# **Combined License Application Review Vogtle Units 3 and 4**

**SER Panel 3**

September 27 – 28, 2011

# Vogtle Switchyard Configuration

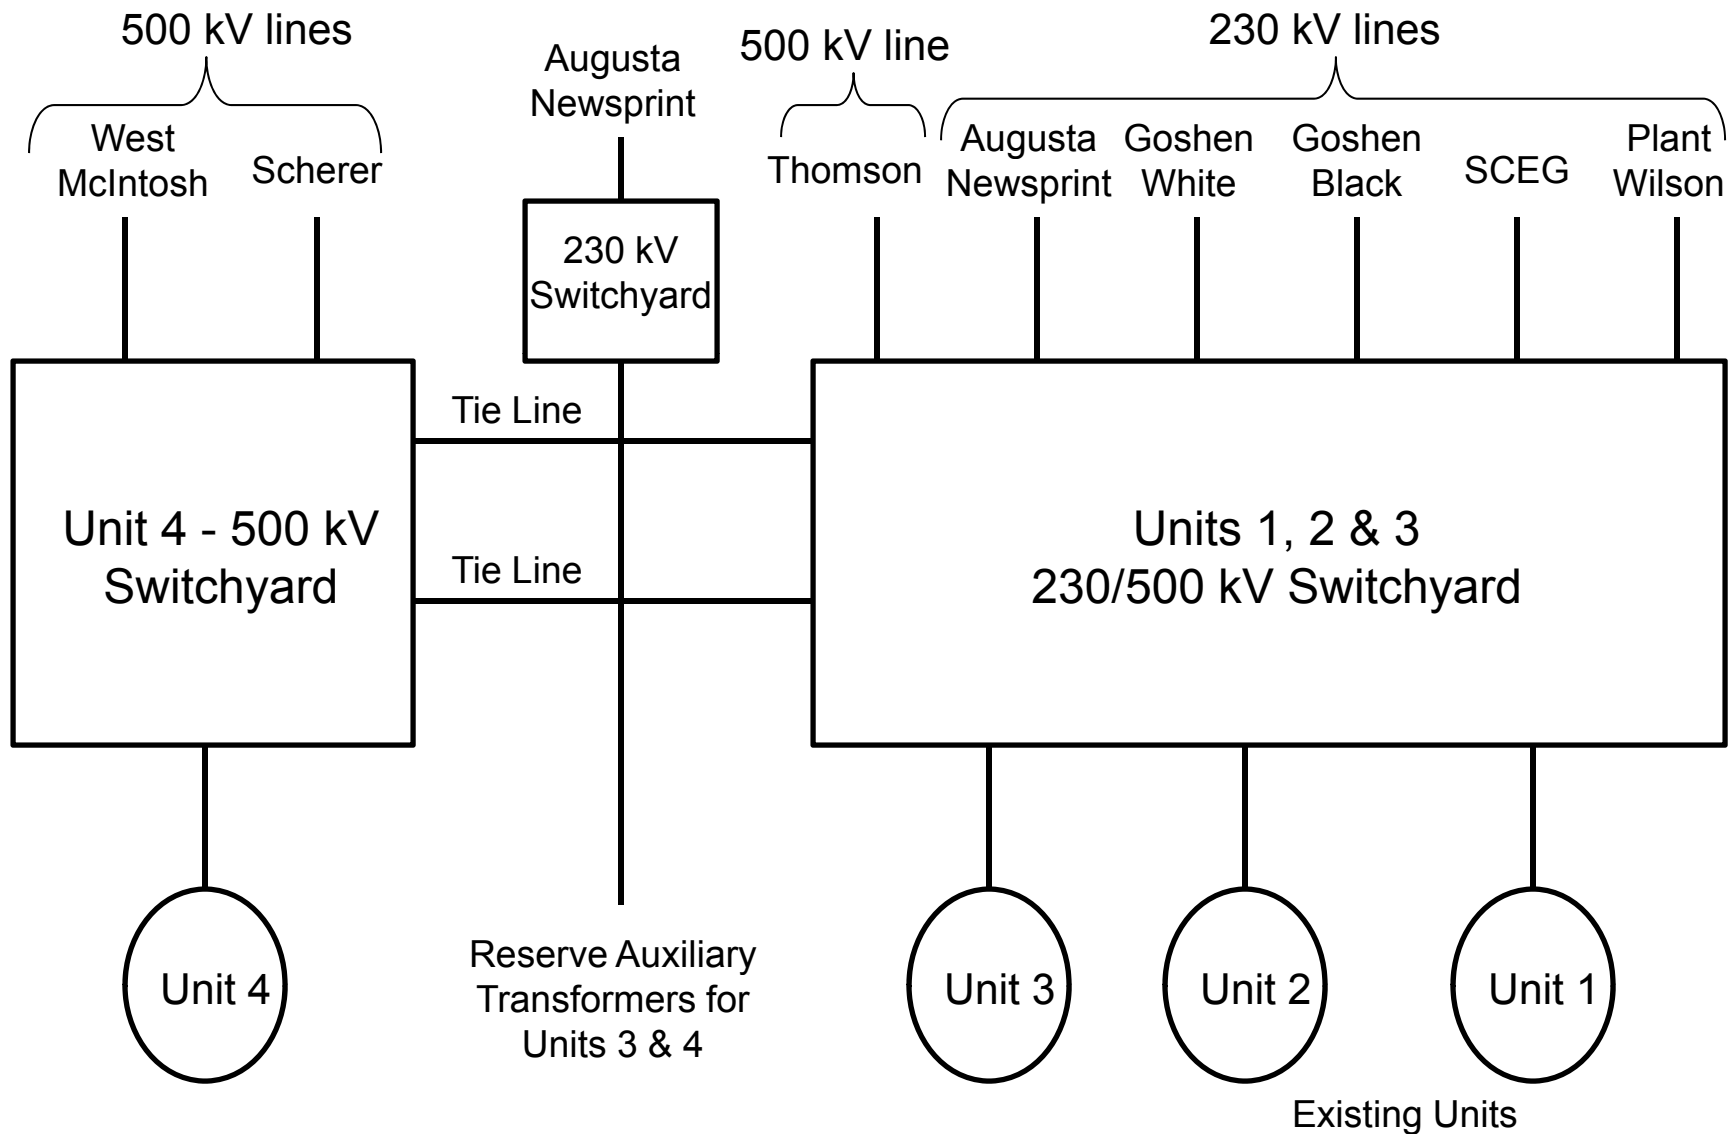
- Unit 3 is connected to the 230/500 kilovolt (kV) switchyard, which is supplied by five 230kV overhead transmission lines and one 500 kV overhead transmission line coming from other substations.
- Unit 4 is connected to a different 500 kV switchyard, which is supplied by two 500kV overhead transmission lines coming from other substations.
- Grid stability analysis was performed by the applicant to satisfy the DCD interface requirement for maintaining adequate reactor coolant pump voltage for 3 seconds after a turbine trip, which was accepted by the staff.
